Model HW 132

Subject Outlet pump improvement

For model HW132

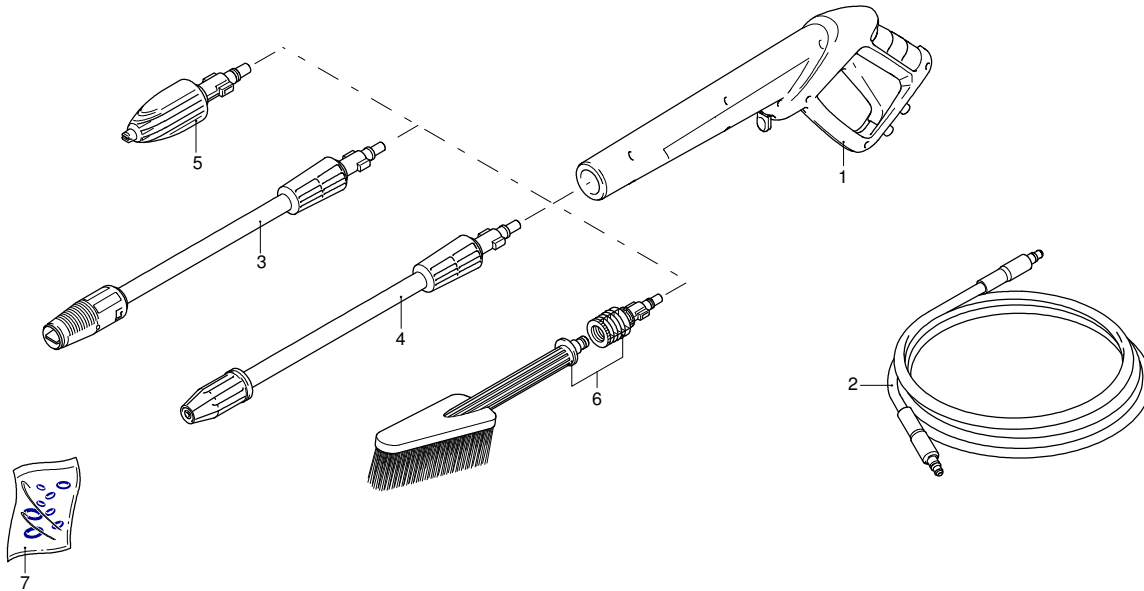
Description The pump outlet has been changed to a new system. An according conversion could be required in case of repair.

Version until Nov 2011					Version from Dec 2011				
Old version: The pump outlet is equipped with a bayonet closure, high pressure hose with clamp connection					New version: The Pump outlet is equipped with a clamp connection to the pump, the high pressure hose with swivel coupling				
Pos.	Q'ty	Old part	Description	I/C	Pos.	Q'ty	New part	Description	Remark
2a	1	364 0960	High pressure hose 8 m	No	2b	1	364 1570	High pressure hose 8 m	Interchangeable as a set with 9b
7	1	364 0870	Inlet pump kit	./.	7	1	364 0870	Inlet pump kit	Remains unchanged
9a	1	364 0970	Electric pump assembly =>2011-11	No	9b	1	364 1620	Electric pump assembly 2011-12 =>	Interchangeable as a set with 2b
8a + 8b	1	42 663	Outlet pump kit	Yes ←	8c	1	42 700	Outlet pump kit	
8c	1	42 700	Outlet pump kit	No	8d		42 693	Outlet pump kit	Interchangeable as a set with 9b and 2b

(I/C) The arrow ← shows, old part can only be replaced by new part.
